**TRUCK, TRANSPORTER, FLOATING BRIDGE, MC3, W/WINCH, MACK,
LAUNCH AND RECOVERY VEHICLE (LRV)**

FITTING OF SKID PLATE TO FRONT LIFT FRAME

MODIFICATION INSTRUCTION

Figure 1 - Front Lift Frame

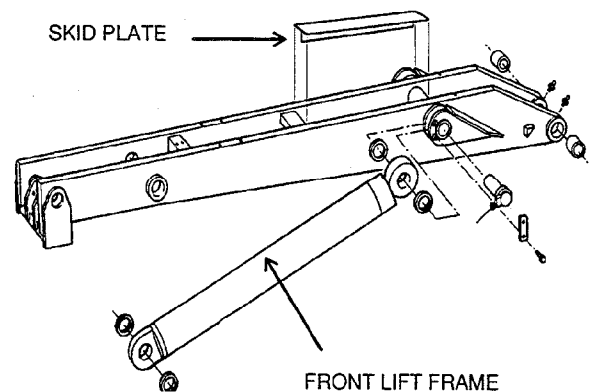
1. This instruction details the fitting of skid plates in the centre of the front lift frame of the LRV. This is to prevent the rope guide plate, on the bottom of the Floating Support Bridge (FSB) module, catching against the divider in the centre of the front lift frame.
2. **Associated Publications.** Reference may be necessary to the latest issue of the following EMEI:
 - a. WORKSHOP A 850 - Modifications, Trial Modifications and Local Modifications to Equipment; and
 - b. WORKSHOP A 851 - Recording Modifications to Equipment - Use of Modification Record Plates and Documentary Requirements.
 - c. WORKSHOP D 700 - Painting of Army Equipment.
3. **Authority.** ECO AEM 5006 is the authority to carry out this modification.

11. **Fitting of Skid Plate.** The procedure for fitting the skid plate is as follows:
 - a. Manufacture skid plate using Items 1 and 2, Table 1, to the specifications detailed in MEA drawing 1789-9.

- b. Weld skid plate centrally on the front lift frame, refer Figure 1 and MEA drawing 1789-9.
